ELEVATIONS
THE MADRID

SHEET
 1
 OF 6

BASEMENT FOUND. PLAN
THE MADRID

BASEMENT FOUND. PLAN

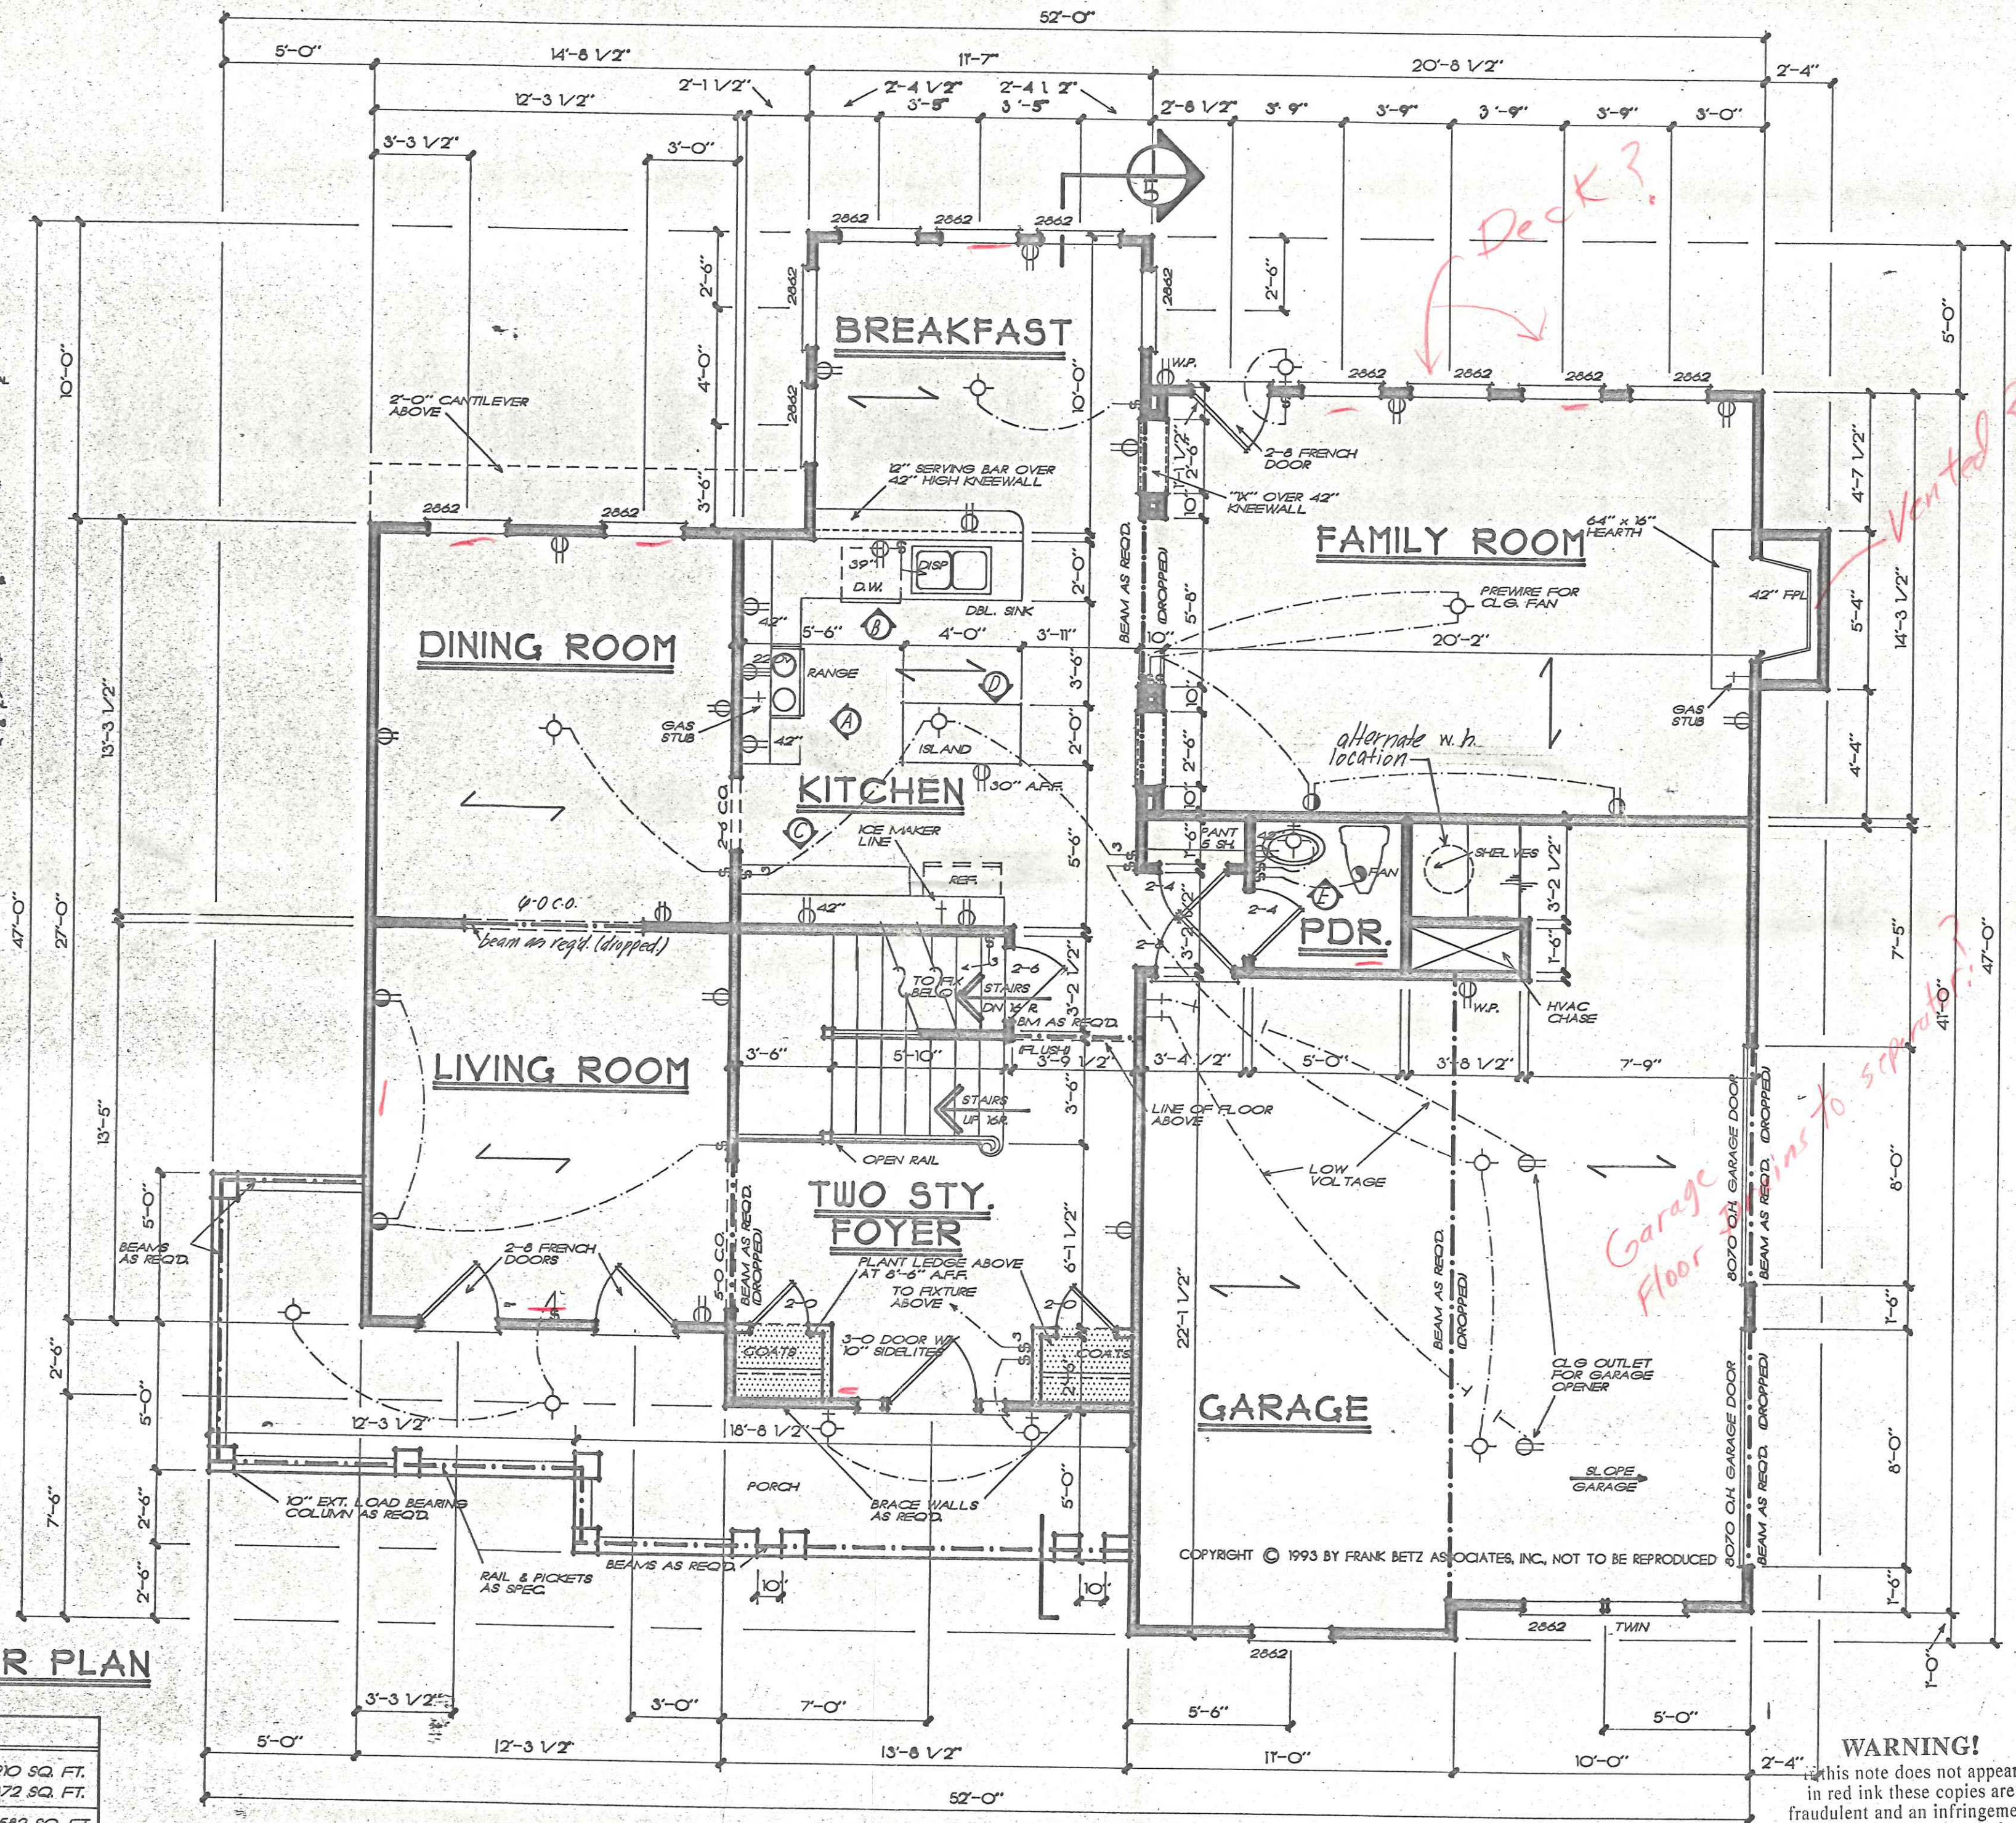
Vapor Barrier under all slabs. Need cross section crawl & basement foot & found

No Sand
